Sterling Designs Limited (Extension)

10 November 2024

Structural Inspection Report

Concrete strength consideration in design report for Building-2 & 3

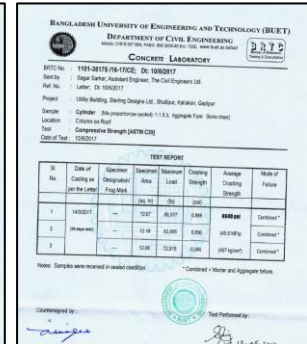
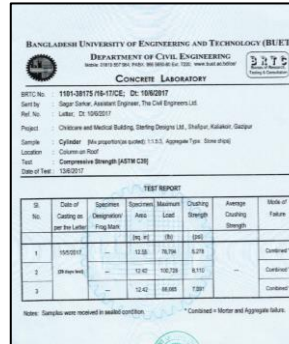
Observation 1: Lack of material test report for (Building-02 & Building-03).

Description: During the inspection, concrete cylinder test report- (1 set from column for Building-2), (1 set from column, 1 set from beam & slab for Building-3,) were available. However, in the design reports of Building 2 & 3, f'_c was considered 24.14 MPa without any justification. The building engineer is required to take the necessary concrete cores to confirm the concrete strength. Update the analysis & design report based on in-situ material strength and submit to RSC for review.

Item No.	Observation	Action Plan	Timeline
1.	Lack of material test report (Building-02).	Verify in-situ concrete strength either by 100 mm diameter cores or existing credible cylinder test reports.	within 6 weeks

2.		The building engineer is required to revise the design report based on the in-situ material strength, the actual framing system, and proper design parameters. Submit the revised design documents to RSC for review.	within 6 weeks

5.	Lack of material test report. (Building-03).	Verify in-situ concrete strength either by 100 mm diameter cores or existing credible cylinder test reports.	within 6 weeks

6.		The building engineer is required to revise the design report based on the in-situ material strength, the actual framing system, and proper design parameters. Submit the revised design documents to RSC for review.	within 6 weeks

Typical floor beam layout

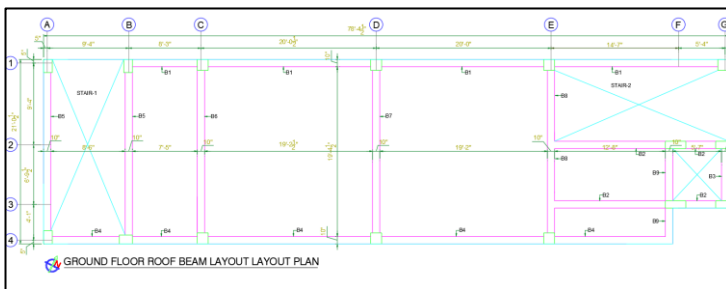
Observation 2: Missing information in as-built drawing (Building-02)

Description: In the structural drawing, structural details of ground floor tie beam were not available. The building engineer is required to survey the structure and update the as-built drawing.

3.		Carry out the suggested remedial if works.	within 6 months
4.	Missing information in as-built drawing (Building-02).	The building engineer is required to survey the structure and update the as-built drawing.	within 6 weeks

Typical floor beam layout

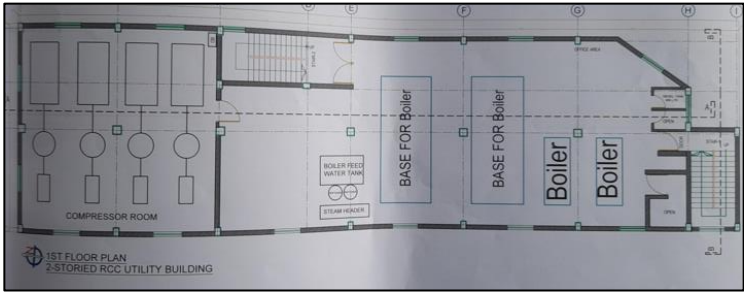
Observation 3: Missing information in as-built drawing of Building-03

Description: In the as-built architectural drawing, build-up thickness was not shown for base of boiler in 1st floor. The building engineer is required to survey the structure and update the as-built drawing.

7.		Carry out the suggested remedial if works.	within 6 months
8.	Missing information in as-built drawing (Building-03).	The building engineer is required to survey the structure and update the as-built drawing.	within 6 weeks
